Access Compliance Report Public Rights-of-Way (Curb Ramps)

Main Street: DEL_MAR_AVE Cross Street: SANTA_ANA_AVE Location: N

ADA ID: RPAT220128161740 Ramp Type: Type 1 - Perpendicular Diagonal Initial Pass/Fail: Pass Overall Compliance: No Severity Score: 26

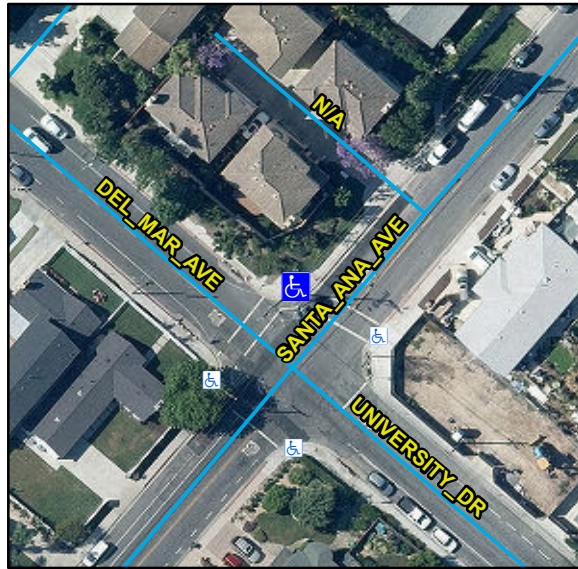
R304.2.2, R304.2.2-Perp, R304.3.2-Para, R304.5.3, R305, R302.7.2, R304.5.4, STD 1115

Yes	Ramp Inside Crosswalk 1	Yes	Yes	Ramp Inside Crosswalk 2	Yes
	Crossing 1 Slope (%)	3.6		Crossing 2 Slope (%)	3.8
	Crossing 1 Cross Slope (%)	1.3		Crossing 2 Cross Slope (%)	0.6
Yes	Gutter Ponding	No	No	Curb Slope	7.7
No	Gutter Lip Height (in)	1.5		Road Run Slope (%)	0.8
No	Gutter Run Slope (%)	6.6		Road Cross Slope (%)	1.8
Yes	Gutter Cross Slope (%)	1.7			
Yes	Overall Surface Condition: Acceptable		Yes	Perp Joint Present	Yes
	Cross Gutter Present?	No		Spandrel Present?	No
	Replace Cross Gutter?	N/A		Replace Spandrel?	N/A

Remove & Replace Curb Ramp With Two New Directional Ramps or Equivalent. Remove & Replace Gutter. Utility Present.
